## SAFETY NOTE

**Product:** Harness Calliplox and Calliplox Reverse.

**Problem:** Rescue Lines possibly may hook on zipper puller inside of the rescue compartment.

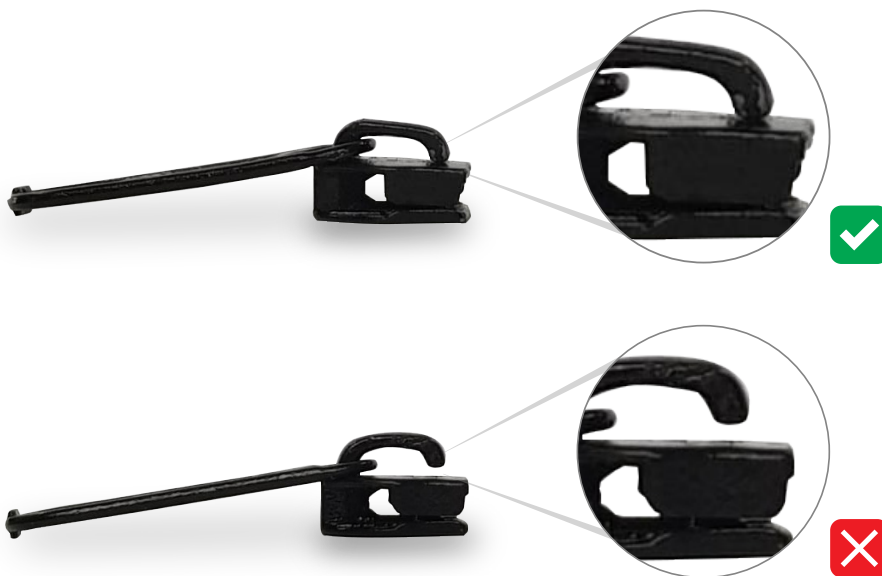
- Check if the zipper pull offers risk to hook the line or cause malfunction of the rescue use

**2) if it is not OK :** You must use pliers to tighten the zipper puller:

**3)** Take the pliers and carefully try to tighten nicely to not damage the zíper.

**4)** Another inspection is necessary until you install your rescue inside of the compartment.
